### Substantive: Fairway Estates Phase II PUD/Subdivision Application

Date: January 10, 2023  
To: City of Florence, Planning Department  
From: Metro Planning, Inc.  
Subject: Substantive Comments for PC 21 39 SUB 03 & PC 21 40 PUD 02

Map 1- Open Space and Parkway Areas, please see attached plan linked below.

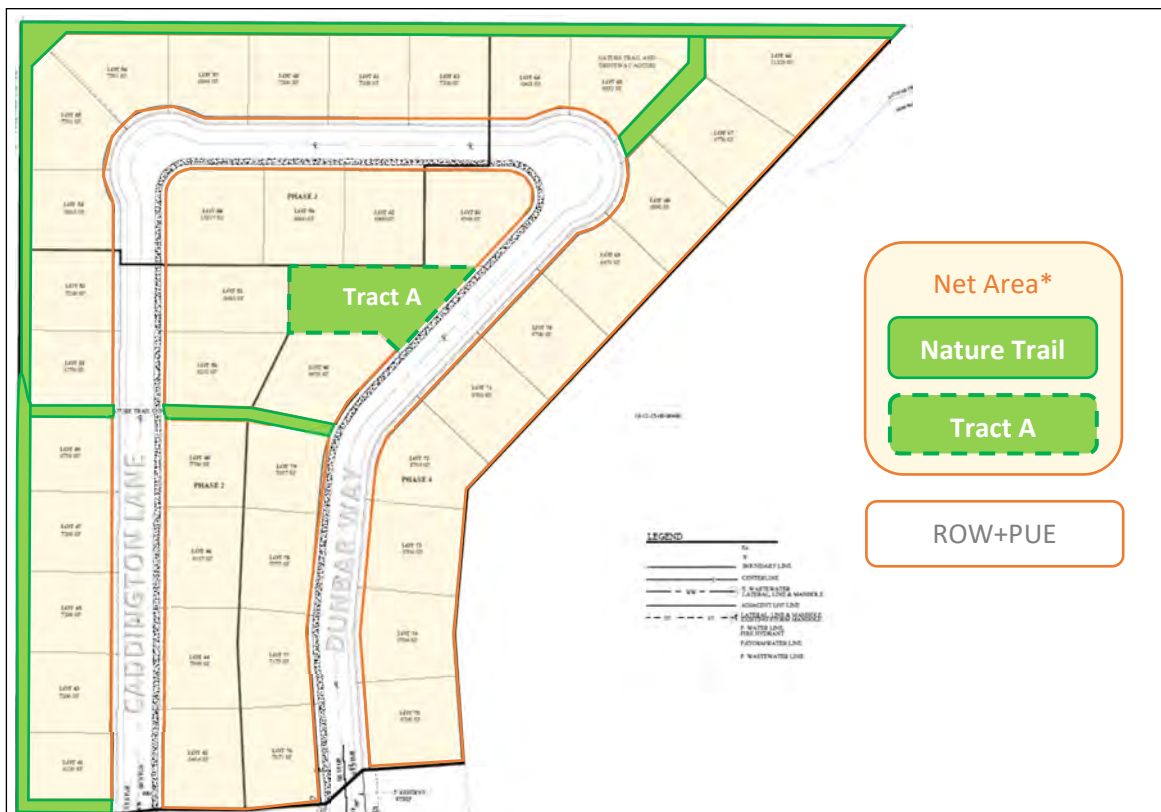
Response: Please see table below for Open Space (and Parkland) area breakdown.

Table above lists proposed Open Space by percent of Net Area. Net Area is the overall site area (extending to the plat boundary) minus the sum of public utility easement (PUE) and right-of-way (ROW) areas. Please see illustration below.

Map 2 - Nature Trail Connection, Revised Utility Map<sup>4</sup>

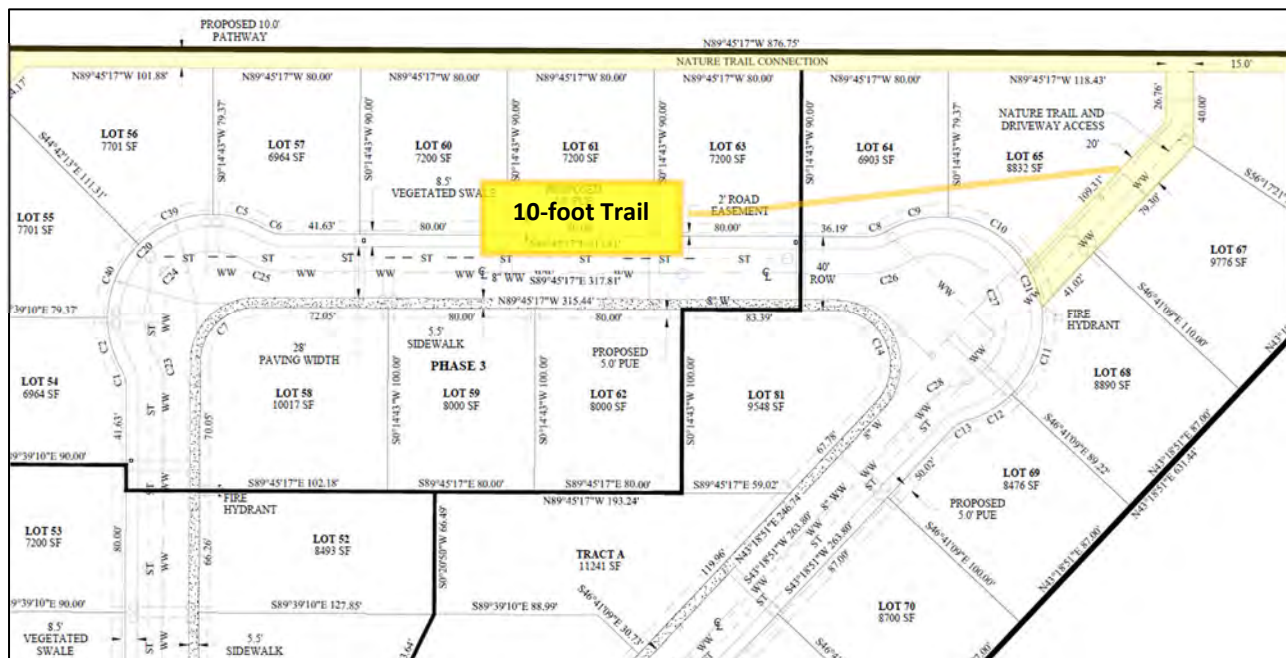
In support of the purpose of FCC 10-36-2-10, applicant proposes a nature trail near the middle of a block in-lieu-of a street connection and also seeks Planning Commission consideration with a request for exception/modification to block length requirement. (Please see written statements below under FCC 11-7 that address exception/modification criteria.)

The ten 10-foot Nature Trail Connection provides a connection mid-block, connecting to right-of-way of both Caddington Lane and Dunbar Way. It connects to the Nature Trail around the perimeter of the subdivision, and (via the perimeter trail) links to the Nature Trail and Driveway Access (illustrated below). The perimeter trail also connects a large tract of city owned Parkland north of the site.

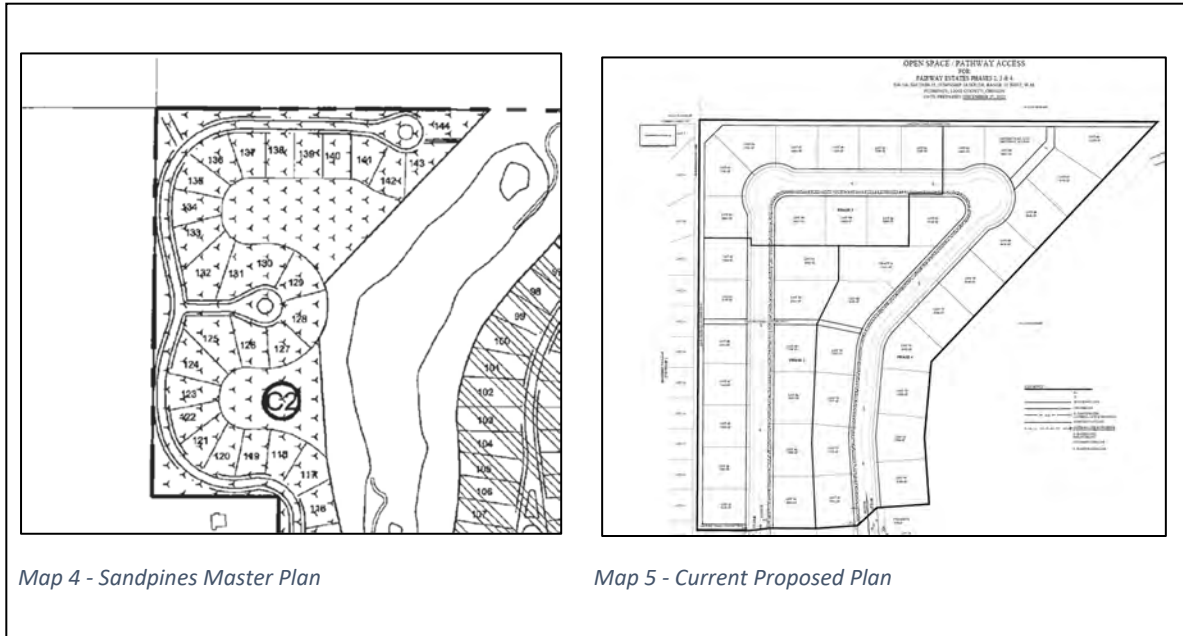
2. Revised block perimeter layout closely approximates a compliant block perimeter, (prior layout did not have a block perimeter at all). Layout promotes better secondary emergency access and improves traffic flow through a looped connection of streets rather than dead-end cul-de-sacs. Nothing involved in this project is injurious to the public. Revised layout is designed to meet fire code and is more amenable to emergency vehicle access as it provides two ingress-egress locations instead of one (proposed in the initial layout).
